Mexican Hat, Utah, Disposal Site

SUBJECT: MEXICAN HAT DISPOSAL SITE
OBSERVATIONAL SITE VISIT

Report: WM-00063/12-001

NRC Trip Report

Figure 12-1. 2011 Annual Compliance Drawing for the Mexican Hat Disposal Site

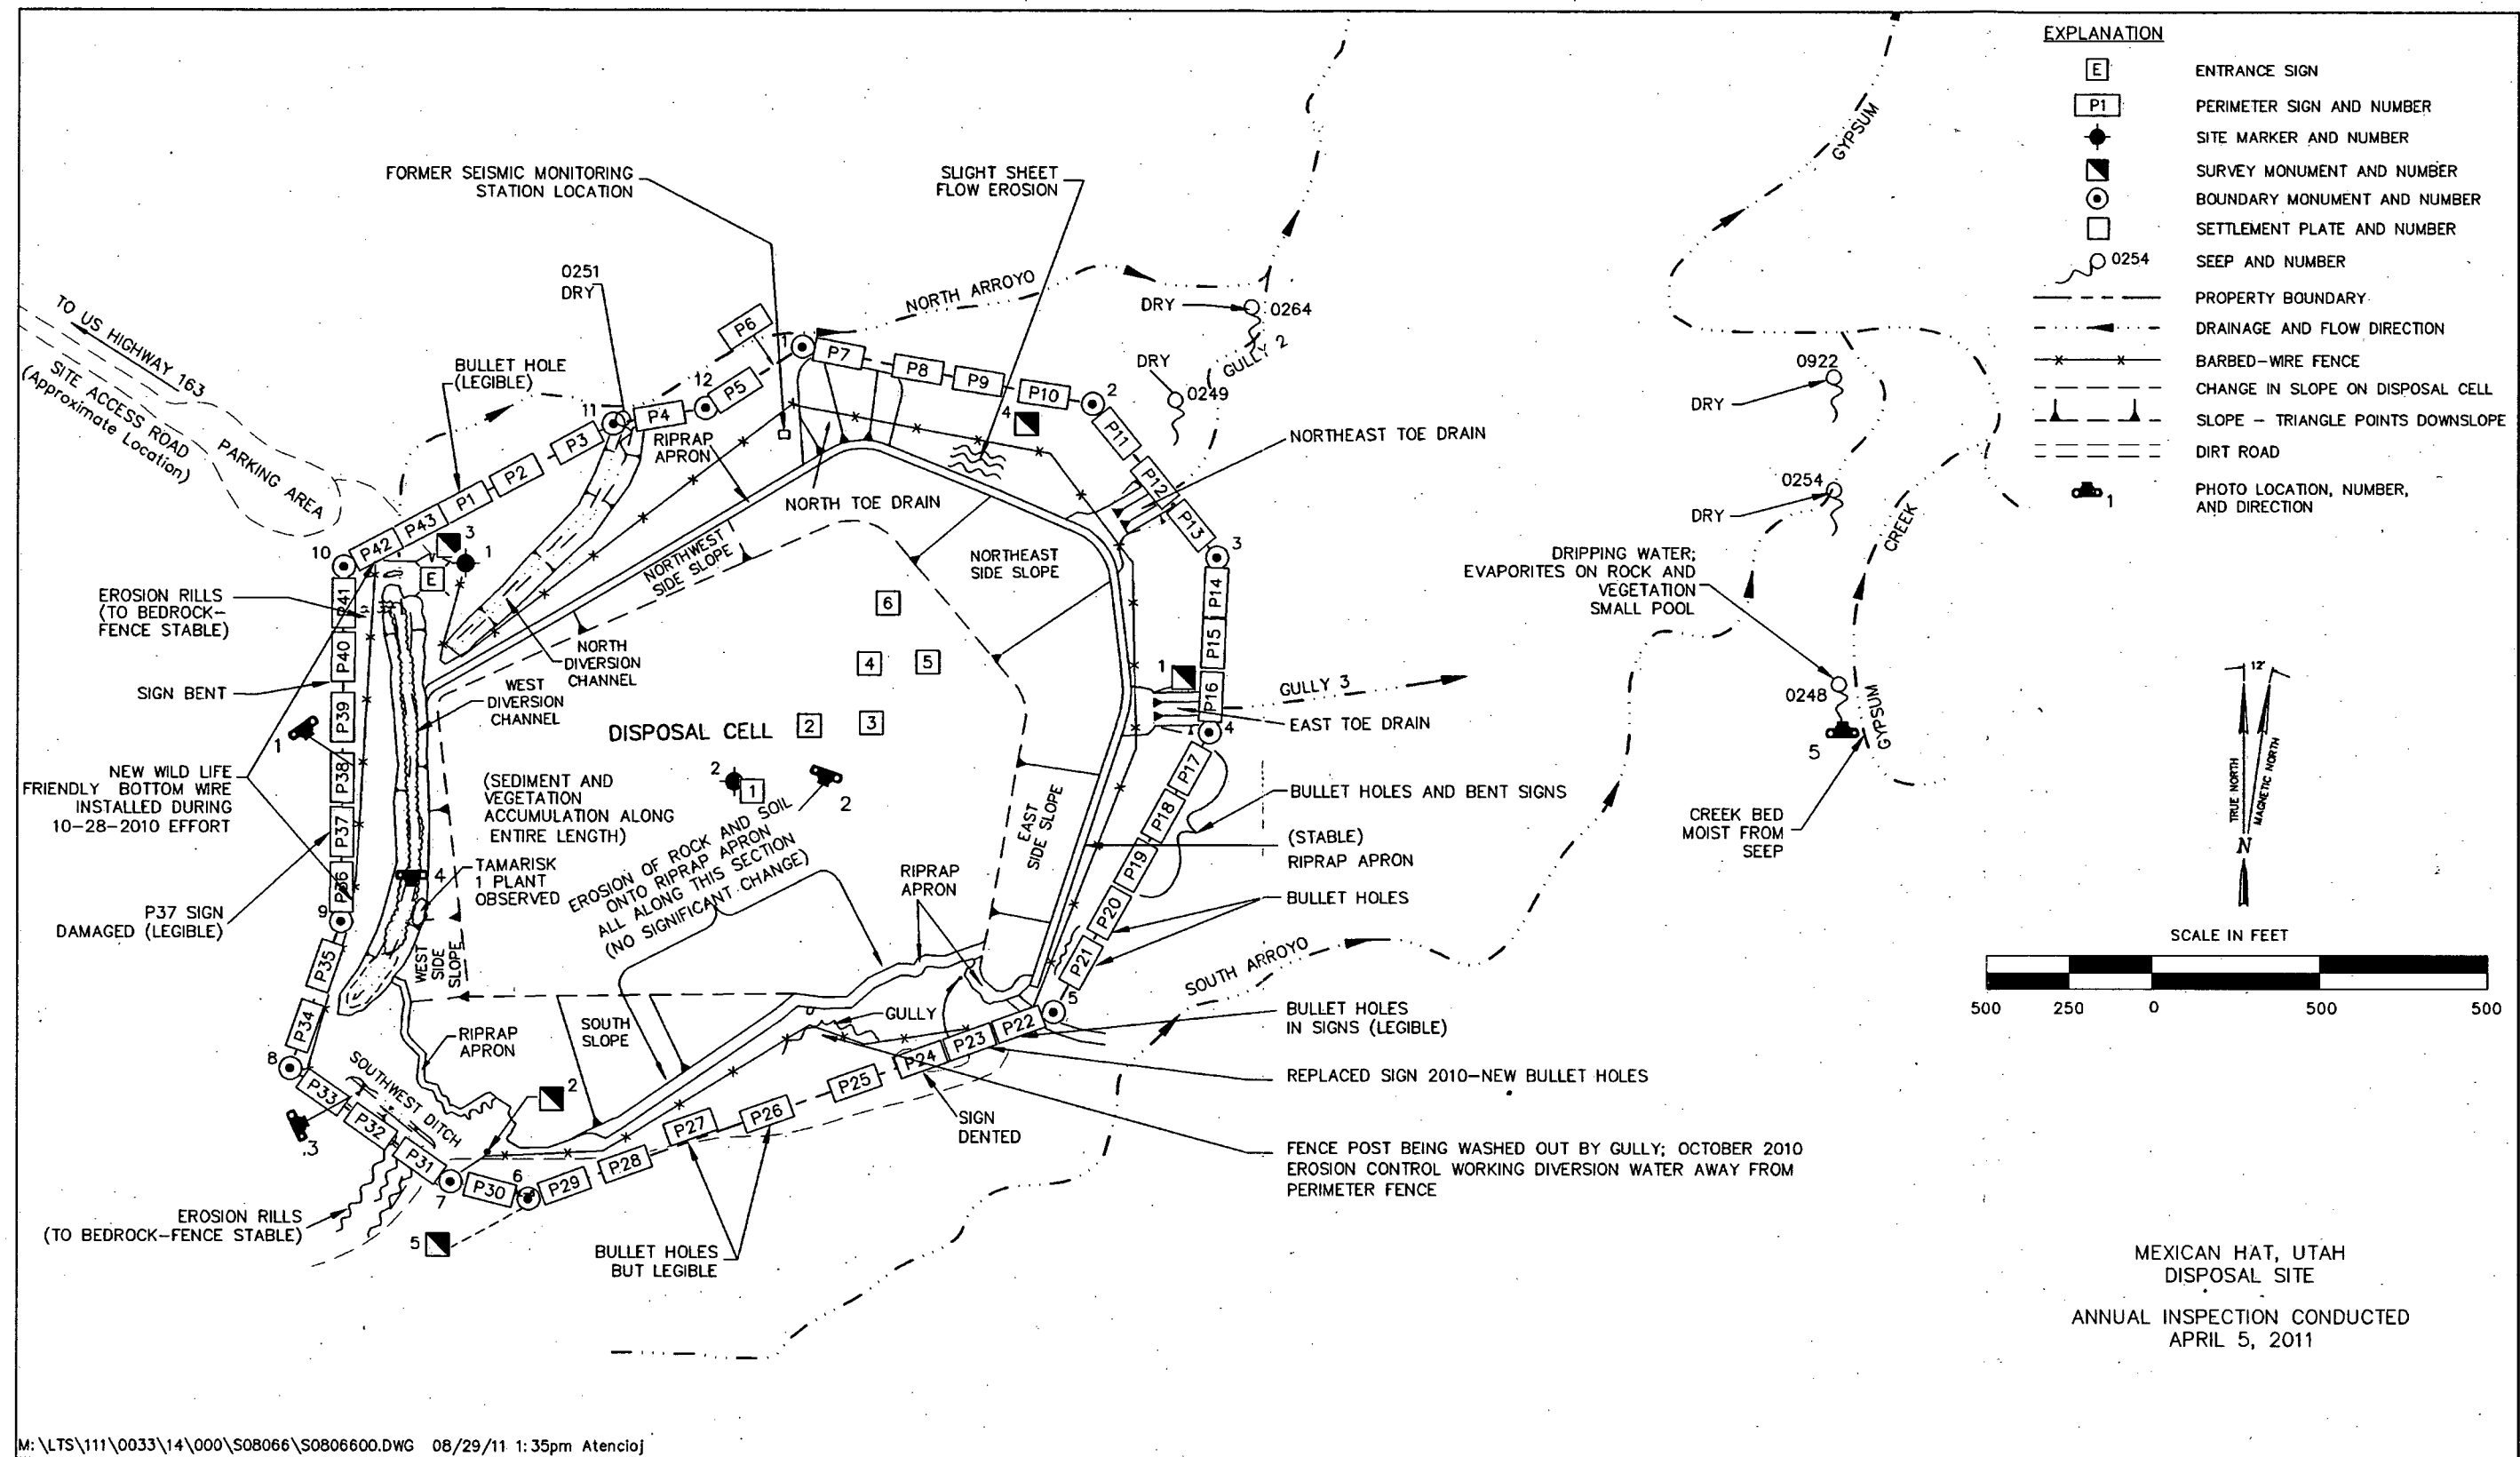
The NRC inspectors noted that the arroyo near the main gate, located on the northwestern side of the disposal cell, was eroding towards the western diversion channel. The NRC staff discussed with the DOE representatives the possible need for intervention at some point in the future. The DOE representatives acknowledged that repairs may be necessary in the future to slow down the erosion. However, the NRC staff concluded that the erosion did not require immediate action, and the erosion did not appear to have a future impact on the disposal cell itself.

The NRC inspectors concluded that the DOE inspectors conducted the site inspection in accordance with LTSP and 10 CFR 40.27 requirements. The condition of the site was nearly identical to the condition that was reported during the previous year's DOE inspection, as documented in the 2011 annual report. The NRC inspectors discussed the erosion of one arroyo with DOE representatives, but this erosion was not affecting the disposal cell. However, DOE may have to address this erosion at some point in the future because it may eventually impact a site diversion channel.
